NS9750B-A1

Thank you for purchasing the NS9750 development kit. Note that your development board is built using the first version of the NS9750 processor, with a part marking of NS9750B-0-C200. The first version had a problem that required use of an external clock to drive the PLL, as well as five other errata. NetSilicon has created an improved version of the processor which resolves the PLL issue and the five errata. The differences are outlined in this document.

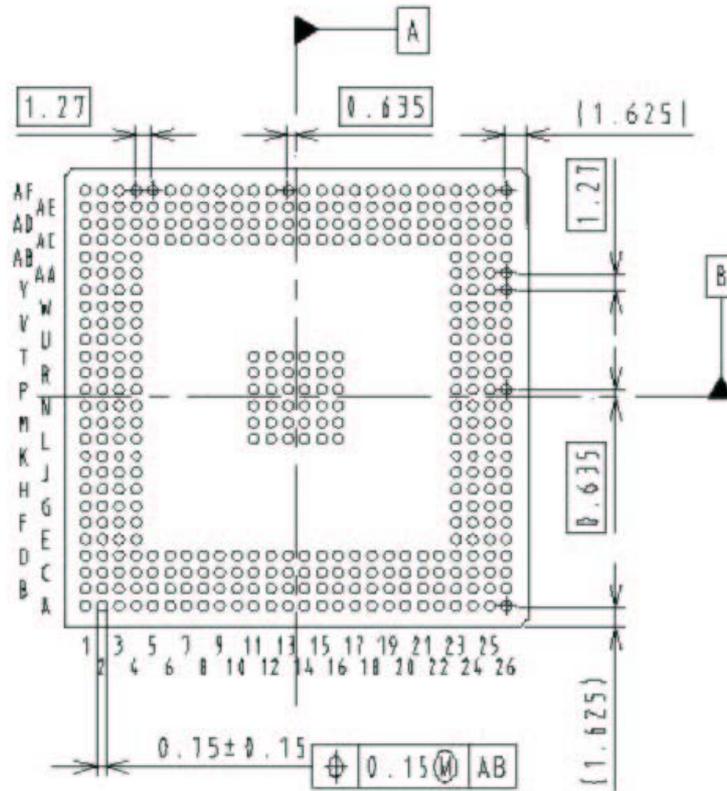
36 new pins

17 pin changes

From 1.5v to Ground

From 3.3v to Ground

Feedback clock to sreset_n

D2 - was clk_in[1], now sreset_n

E3 - was clk_in[2], now sreset_n_enable

E2 - was clk_in[3], now tie to GND
